LAND AT GREVATT'S LANE, CLIMPING STAGE 1 RSA – DESIGNER'S RESPONSE

LAND AT GREVATT'S LANE, CLIMPING

Stage 1 RSA – Designer's Response

**Land to the South of Grevatt's Lane, Climping.
Proposed Highway Works**

Audit Plan

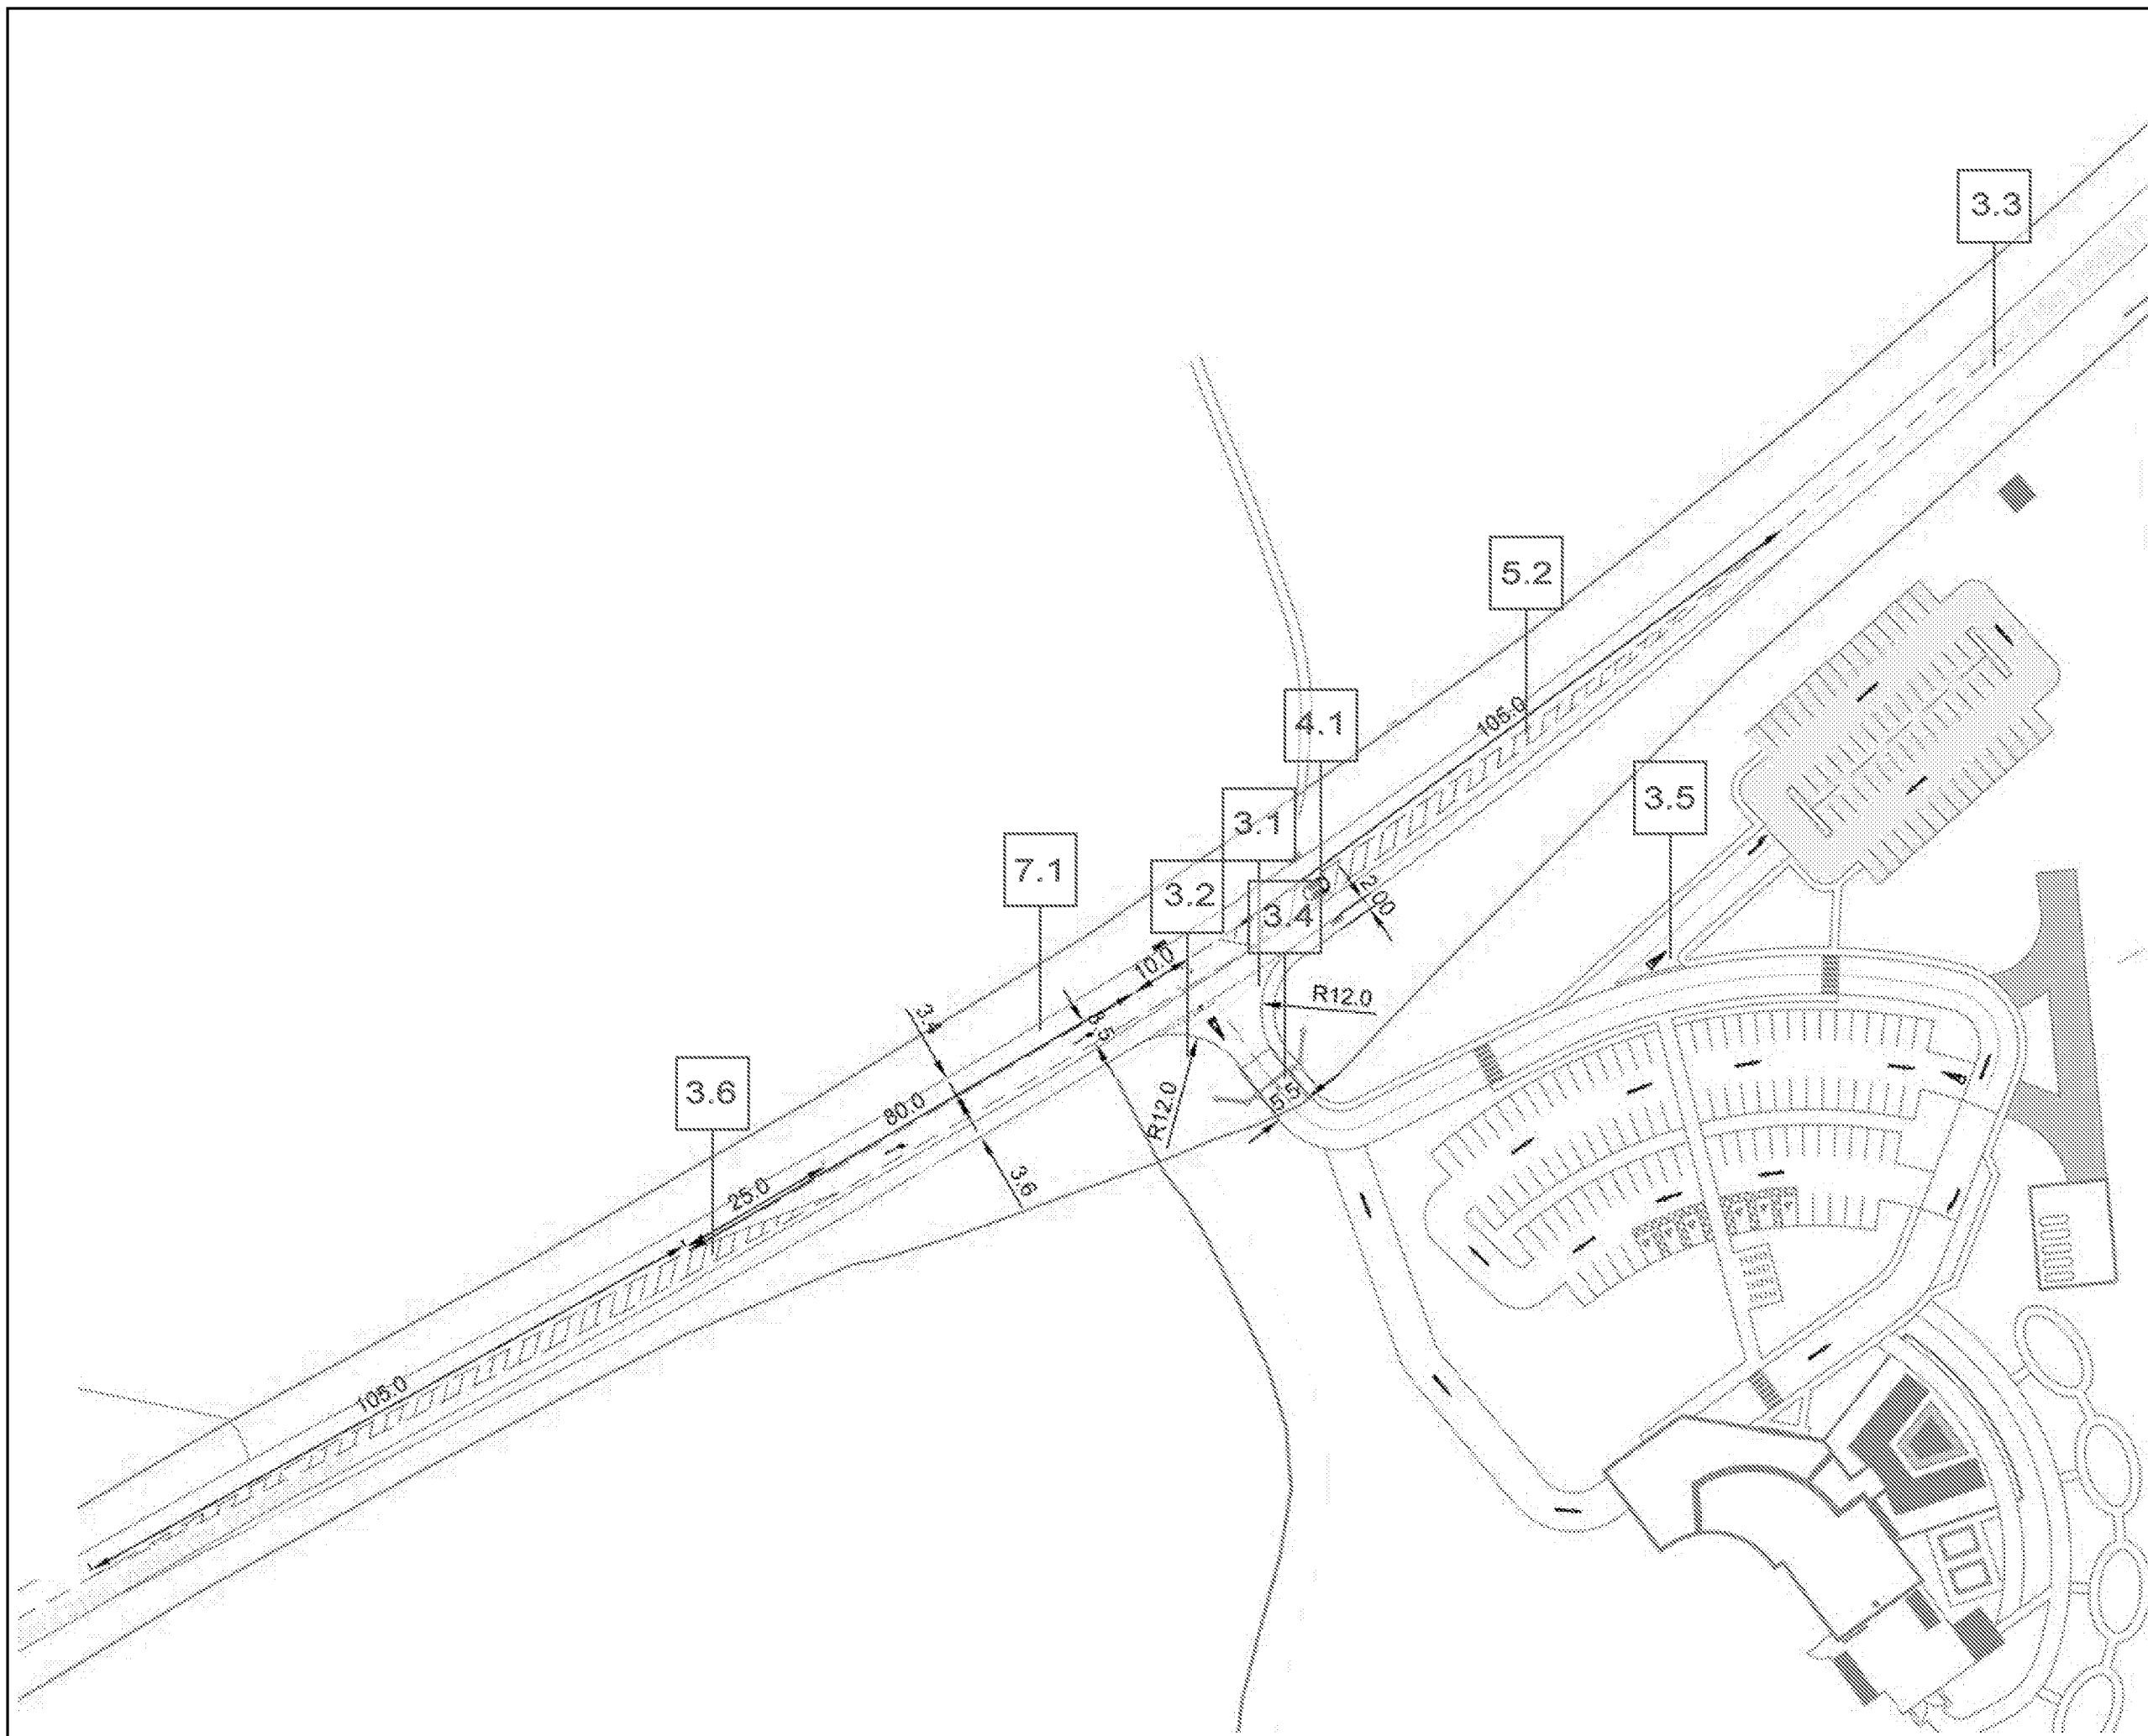
1.9 The location of the site is shown on Figure 1 Site Location Plan and Figure 2 Aerial Photo. The area of the audit extends solely to the works shown on the drawings included in the Audit Brief. Any issues identified are cross-referenced by paragraph number to the Audit Plans (Figure 3).

Title
REFUSE VEHICLE SWEEP PATH ANALYSIS
ENTERING AND EXITING THE SITE

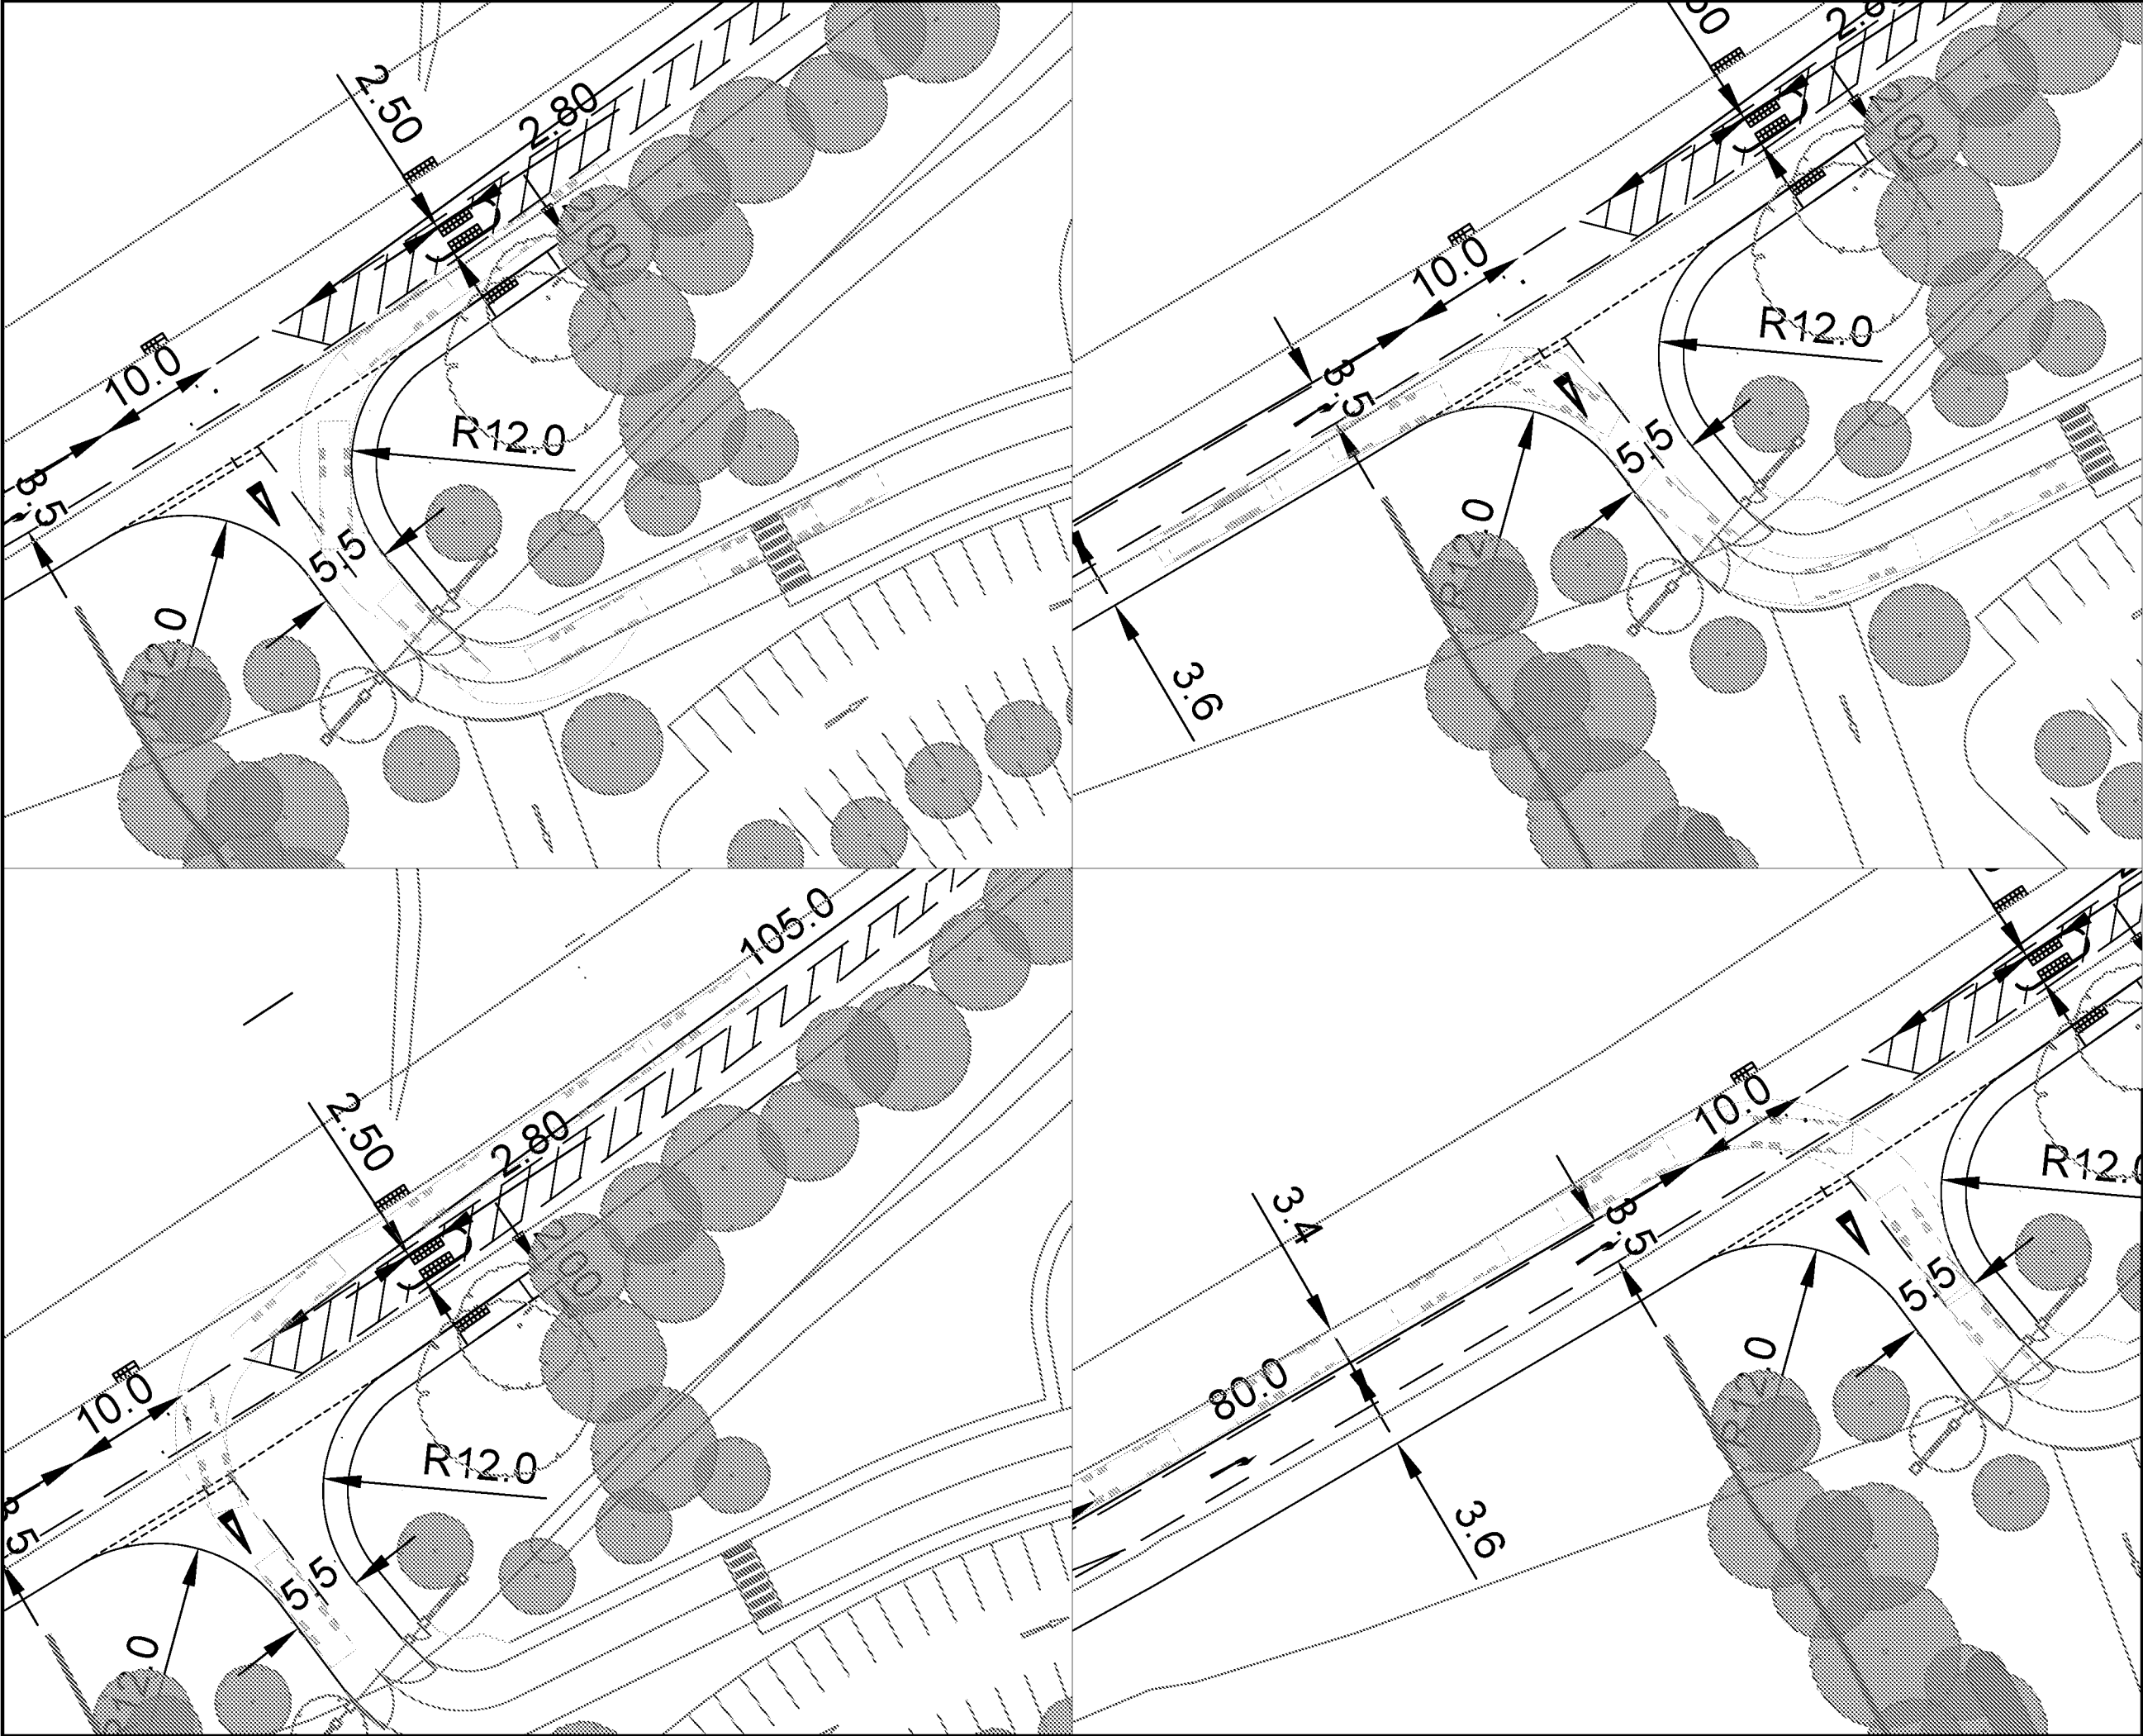
No swept path assessment is provided. The development may attract occasional large vehicles that without sufficient carriageway space may lead to damage-type collisions or collisions with users of the footway if the footway is overrun.

It is recommended that a swept path assessment be undertaken with for the largest typical vehicle anticipated to regularly and frequently visit the site to demonstrate safe and efficient access.

- 2.1.1 Swept-path assessment for a large refuse vehicle measuring 10.2m in length has been undertaken in accordance with Arun's refuse collection requirements, which is the largest typical vehicle anticipated to regularly and frequently visit the site. This drawing (BWREDE-SP4-P3) is included as **Appendix B**.

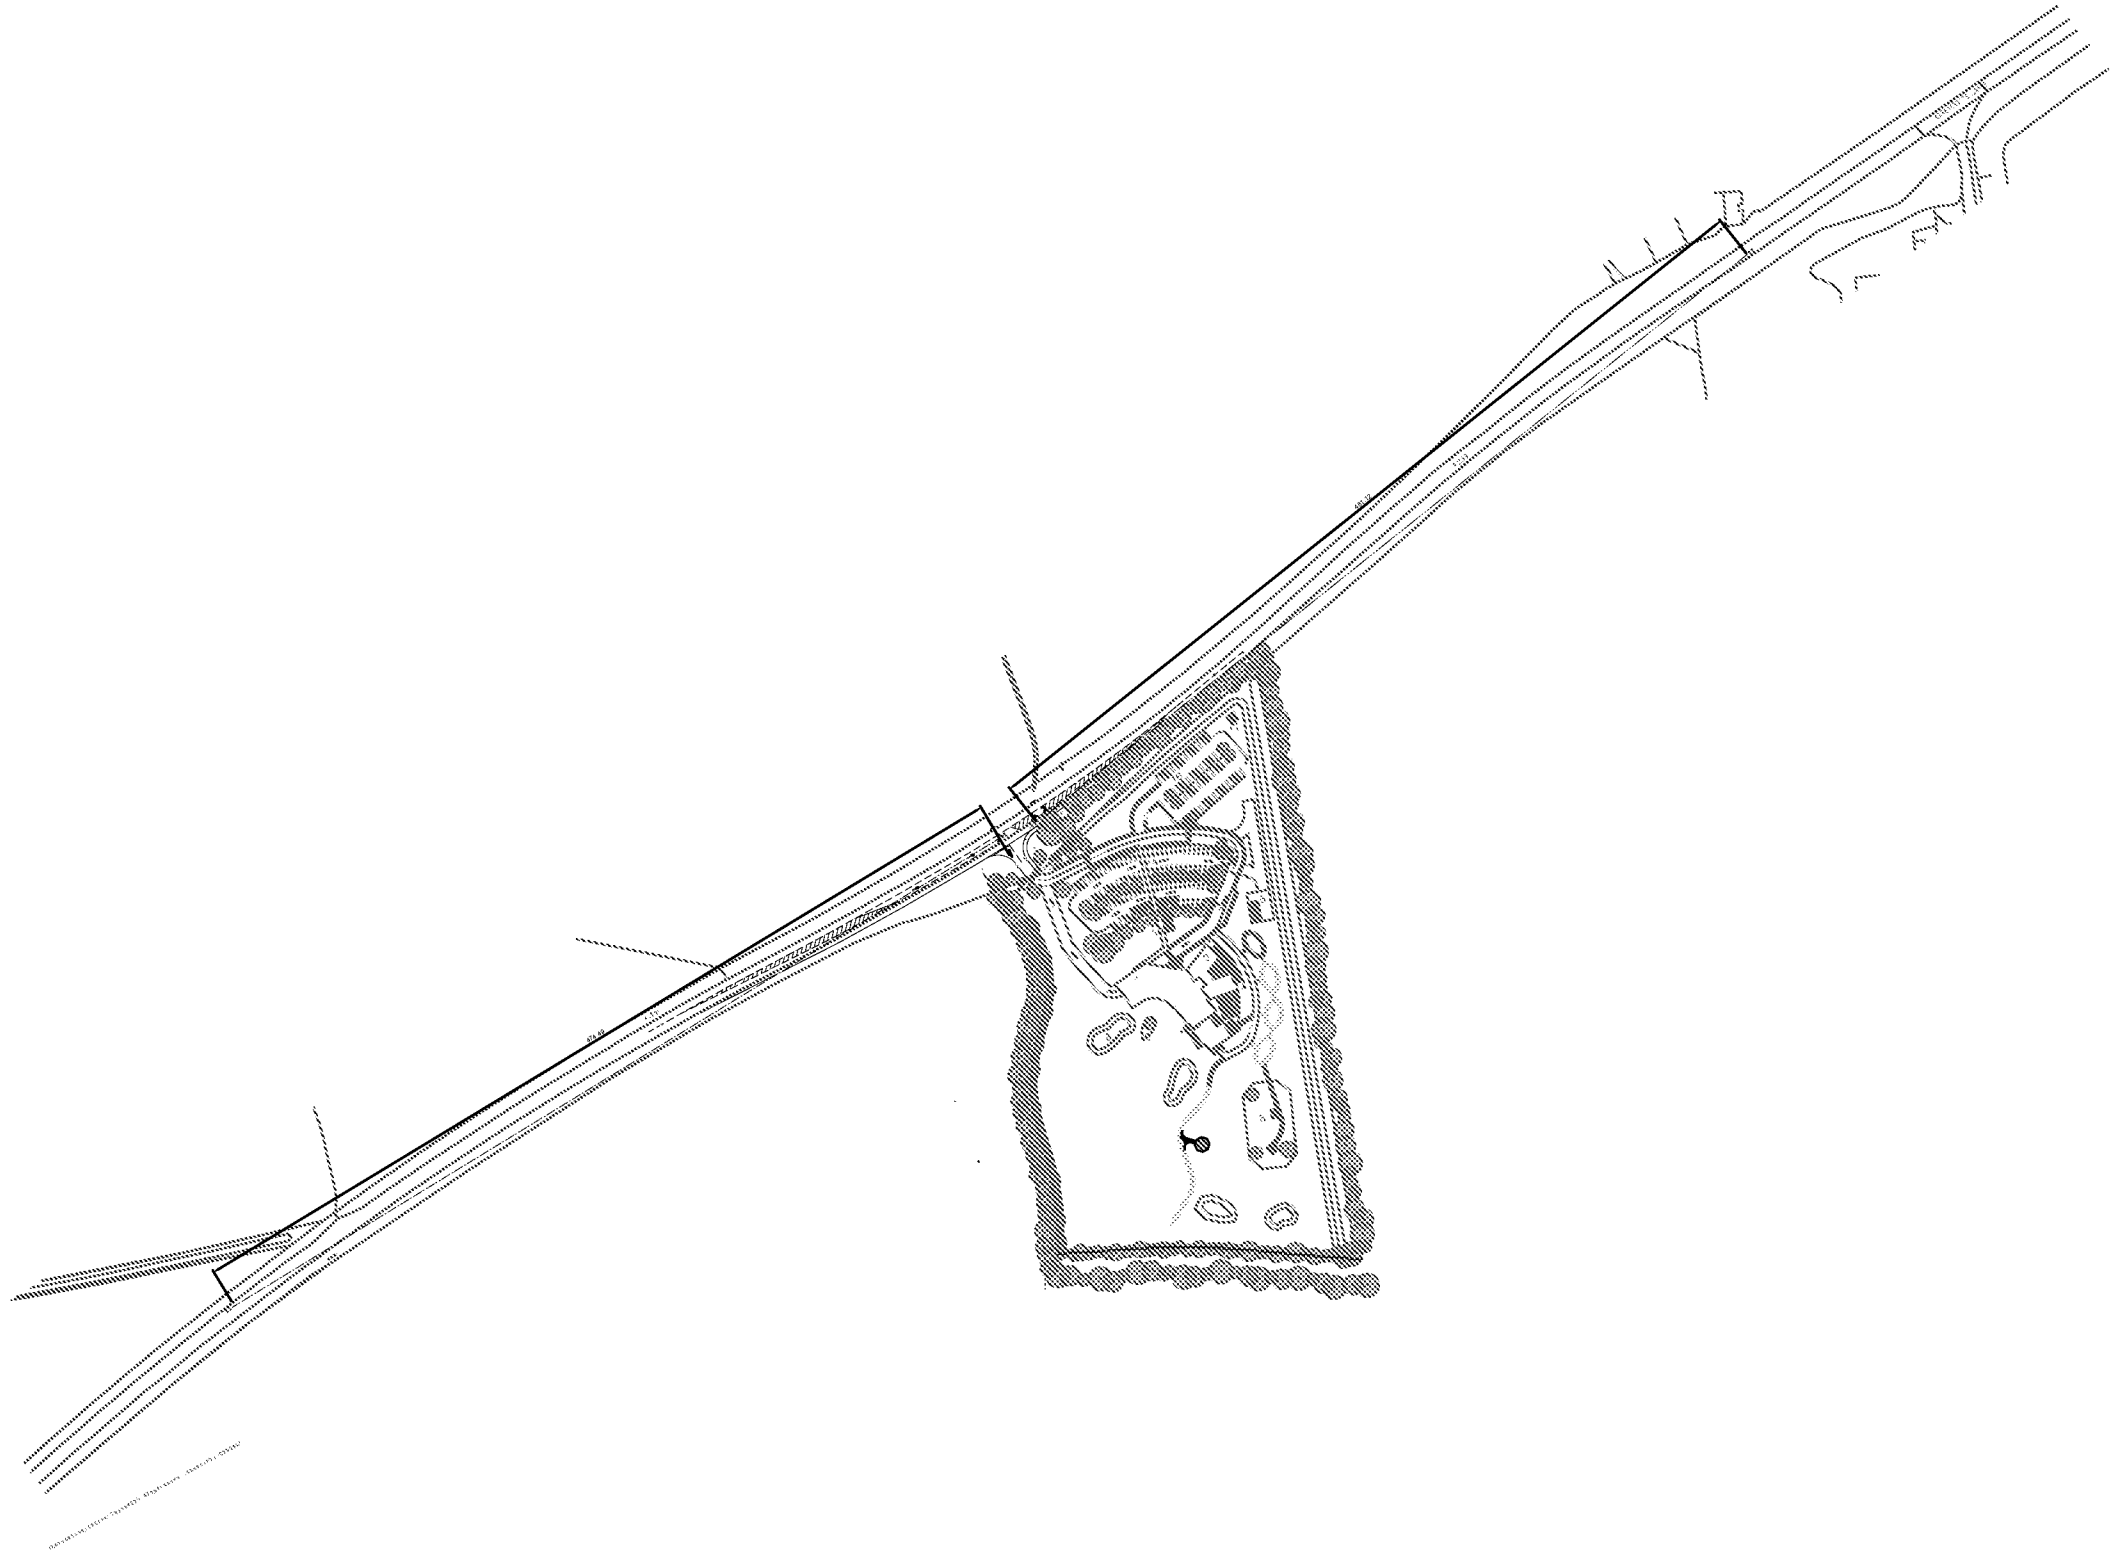
No forward visibility is shown on the drawings. Lack of sufficient forward visibility can lead to late-braking decisions, skidding, and loss-of-control type incidents including collisions with turning traffic.

It is recommended that appropriate forward visibility provided.

- 2.3.1 A drawing has been provided to demonstrate forward visibility along Grevatt's Lane to a vehicle turning left into the site and waiting to turn right into the site, which demonstrates maximum achievable forward visibility of over 470m in each direction within the highway boundary. A second drawing has also been prepared to demonstrate visibility in accordance with the speed limit of 60mph (215m). These drawings (BWREDE-SK03-P2 and BWREDE-SK04-P2) are included as **Appendix C**.
